Re: FortisBC Energy Inc. (FEI)

Revised Renewable Gas Program Application – Stage 2 (Application)

Response to the British Columbia Utilities Commission (BCUC) Information Request (IR) No. 1 on FEI's Rebuttal Evidence to the City of Vancouver, City of Victoria, City of Richmond and Lulu Island Energy Company Ltd., and Districts of Saanich and North Vancouver (CoV)

Figure 1: BC Building Code Extract for the Opt-in Zero Carbon Step Code³

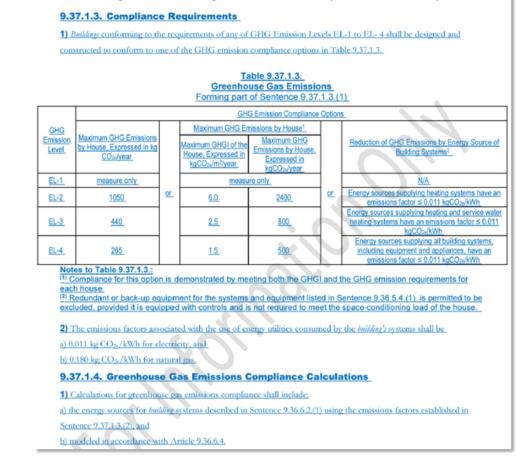
2.1 Please clarify to which of FEI's customer types (e.g. residential, commercial) will the amended BC Building Code and Zero Carbon Step Code be applicable to.

5 The amended BC Building Code and opt-in Zero Carbon Step Code will be applicable to both 6 residential and commercial customer types. The opt-in Zero Carbon Step Code extract referenced 7 in the preamble applies to Part 9 buildings, i.e., housing and small buildings (that are up to three storeys in height and an area not exceeding 600 m² in area). The opt-in Zero Carbon Step Code 8 9 is also applicable to Part 3 buildings, which are commercial and multi-family buildings that exceed 10 three storeys or exceed 600 m² in area. FEI's proposed Renewable Gas Connections would be 11 applicable to all residential applications, whether Part 3 or Part 9. Since commercial energy use 12 for buildings varies substantially from one building or commercial use to another, the use of RNG 13 to meet the targets would need to be modelled and would vary substantially. 14
